# Access Compliance Report

## Public Rights-of-Way

### (Curb Ramps)

Intersection ID: 48587	Main Street: STONEY_CREEK_LN	Cross Street: UNIVERSITY_CITY_BV	Location: NE
ADA ID: 9968F3B255A1	Ramp Type: Perp	Initial Pass/Fail: Fail	Overall Compliance: No
Severity Score: 8.75			
Codes/Mitigation Info/Possible Solution		Field Measurements/Component Compliance

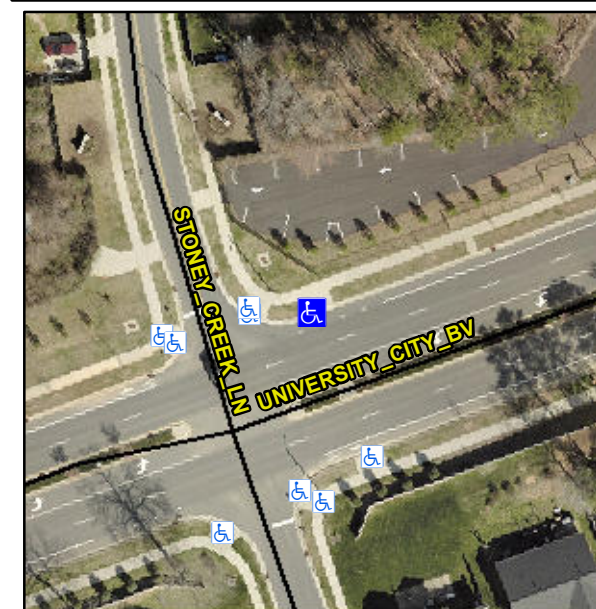
**Not Found, R304.5.1**

Compliance	Description	Data	Compliance	Description	Data
N/A	Ramp Length (in)	95.0	Yes	Ramp Slope (%)	6.2
No	Ramp Width (in)	47.5	Yes	Ramp XSlope (%)	0.0
N/A	Flare Type LT	N/A	N/A	Flare Type RT	N/A
N/A	Flare Slope LT (%)	N/A	N/A	Flare Slope RT (%)	N/A
N/A	Flare Traversable LT?	N/A	N/A	Flare Traversable RT?	N/A
N/A	Landing Length (in)	N/A	N/A	DWS Provided?	N/A
N/A	Landing Width (in)	N/A	N/A	DWS Contrast?	N/A
N/A	Landing Slope (%)	N/A	N/A	DWS Length (in)	N/A
N/A	Landing X Slope (%)	N/A	N/A	DWS Full Width?	N/A
N/A	Landing Curb? (Y/N)	N/A	N/A	DWS Offset (in)	N/A
N/A	Shared Landing?	N/A			
N/A	Gutter Ponding?	N/A	N/A	Gutter Slope (%)	N/A
N/A	Gutter Lip Ht (in)	N/A	N/A	Gutter X Slope (%)	N/A
N/A	Painted X Walk1?	No	N/A	Painted X Walk2?	N/A
	X Walk 1 Direction	To S		X Walk 2 Direction	N/A
N/A	X Walk 1 Width (in)	N/A	N/A	X Walk 2 Width (in)	N/A
	X Walk 1 Slope (%)	0.5		X Walk 2 Slope (%)	N/A
	X Walk 1 X Slope (%)	0.9		X Walk 2 X Slope (%)	N/A

**Remove & Replace Entire Ramp.**
